## ENVIRONMENTAL PROTECTION AGENCY

[EPA-R08-OAR-2010-0406; FRL-9648-3]

#### **Approval and Promulgation of Implementation Plans; North Dakota; Regional Haze State Implementation Plan; Federal Implementation Plan for Interstate Transport of Pollution Affecting Visibility and Regional Haze**

**ACTION:** Final rule.

Figure 1. Coal-Fired Boilers Operating Below 0.17 lb/MMBtu

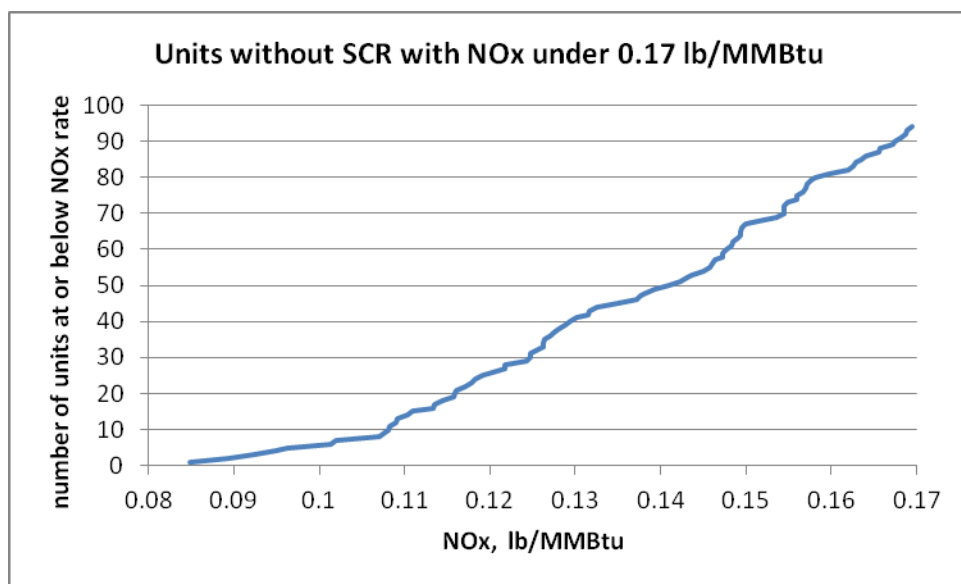
Analysis of emissions data found significant discrepancies in Figures 2.2 and 2.3 of GRE's November 2011 Refined Analysis. A review of EPA Title IV data for 2010 showed 94 coal-fired boilers that do not have SCR achieve annual emissions levels below 0.17 lb/MMBtu, with the median slightly under 0.14 lb/MMBtu (see Figure 1 below). Of these, ten of them are using SNCR in combination with combustion controls to achieve under 0.17 lb/MMBtu. See docket for a list of these facilities. Of these ten, three are supercritical tangentially-fired boilers that use lignite coal with emissions below 0.14 lb/MMBtu. These include Big Brown 1 and Monticello 1 and 2, as discussed earlier in our responses. In addition, the NEEDS Database v.4.10 for the Final Transport Rule in the CSAPR docket includes two tangentially-fired coal/steam units from North Carolina with LNC3 and SNCR that had emission rates of 0.159 lb/MMBtu and 0.164 lb/MMBtu.

As we explain elsewhere, we have decided to revise the BART limit from 0.12 lb/MMBtu to 0.13 lb/MMBtu on a 30-day rolling average.
